NEW COVENANT CHURCH
7200 HOLLY AVE. NE
C19/D049

GRADING PLAN REVISION

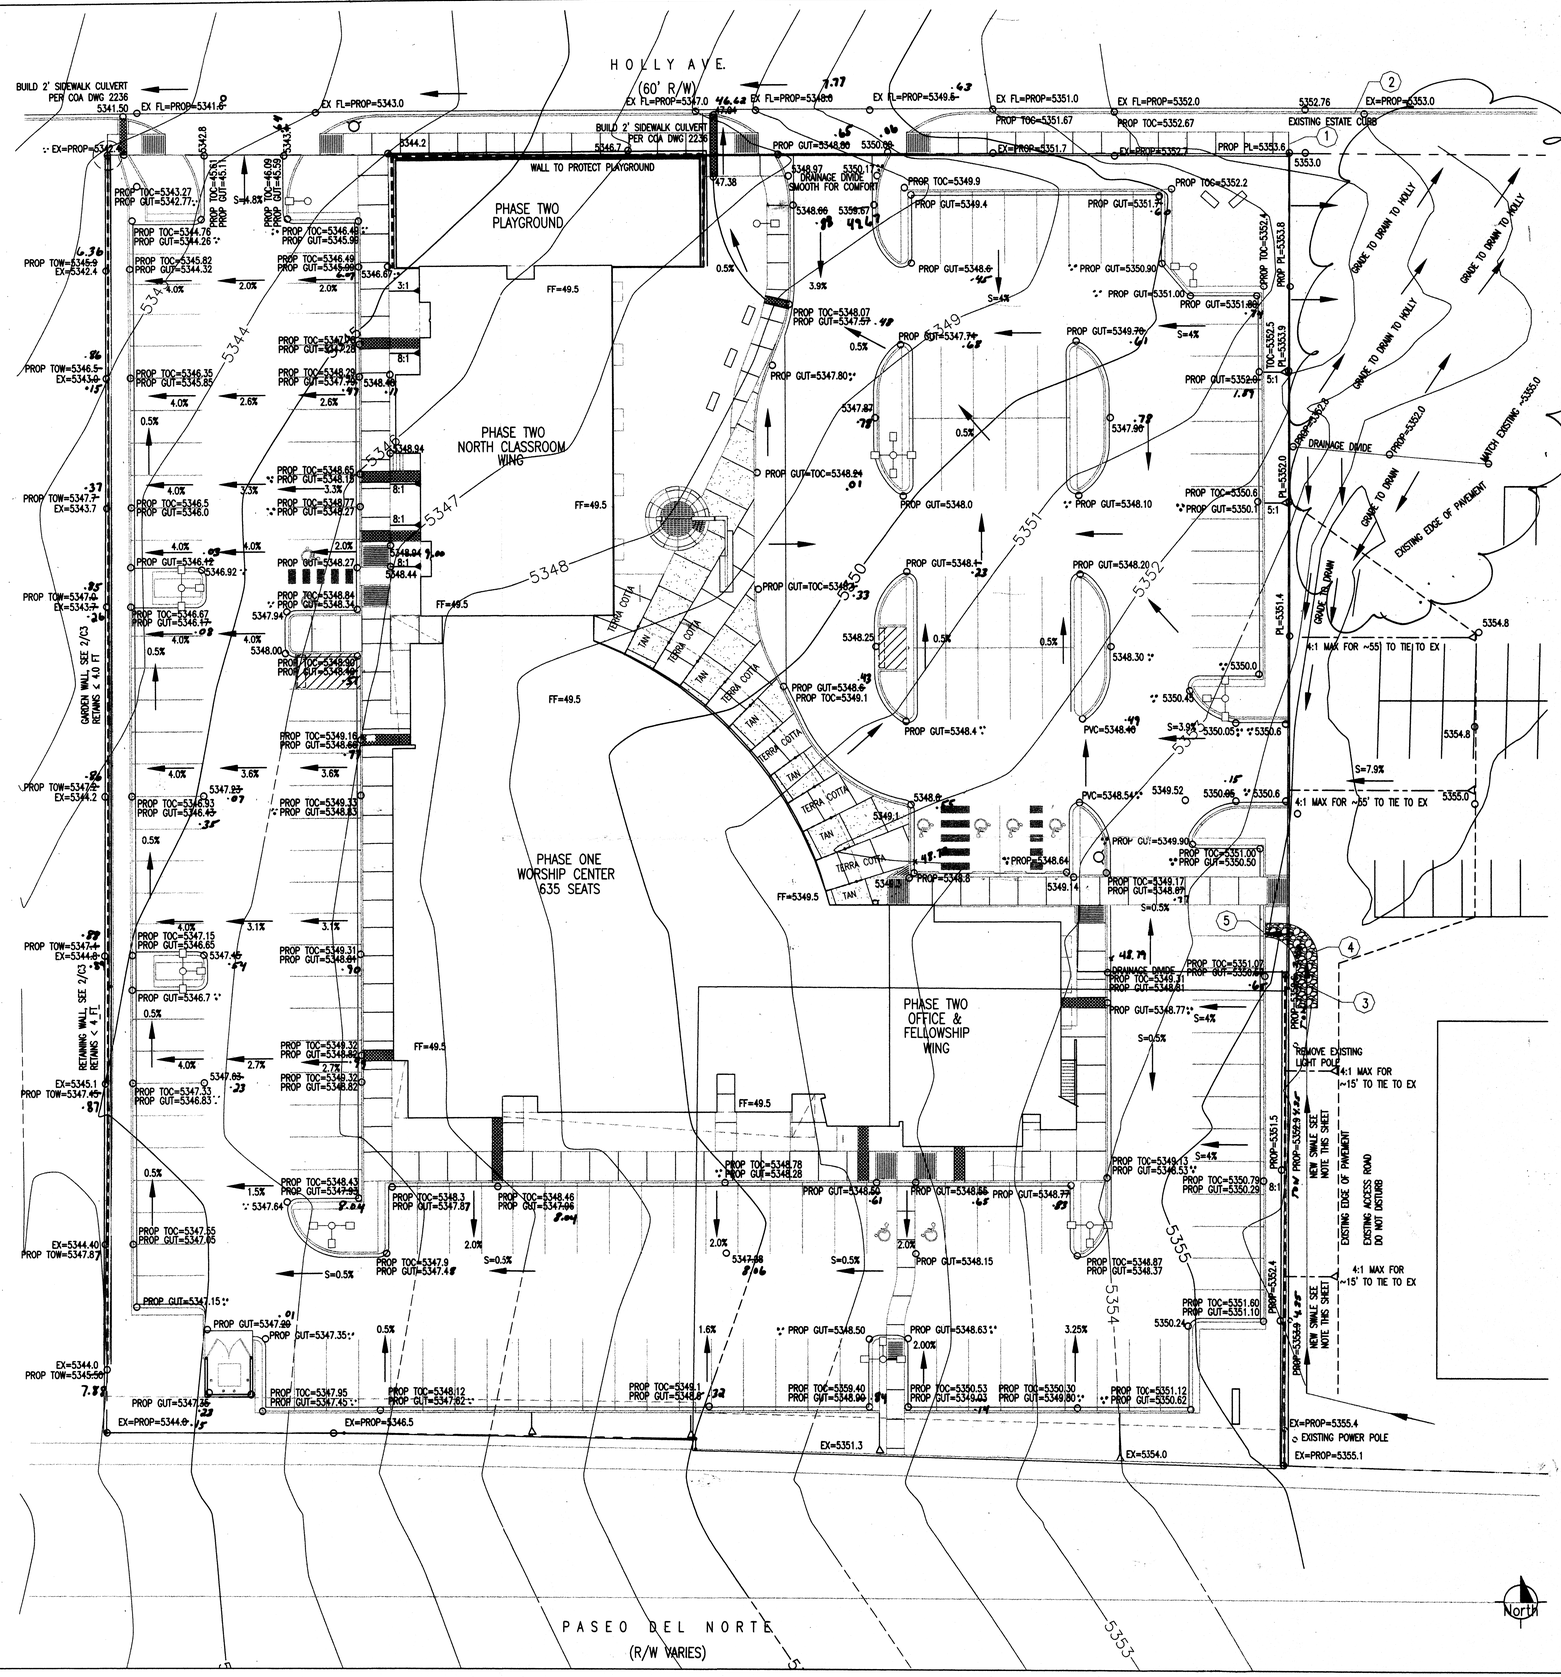
DEFICIENCIES: ~~NONE~~ GRADE TO DRAIN OF NW CORNER TO HOLLY - SEE BUBBLE
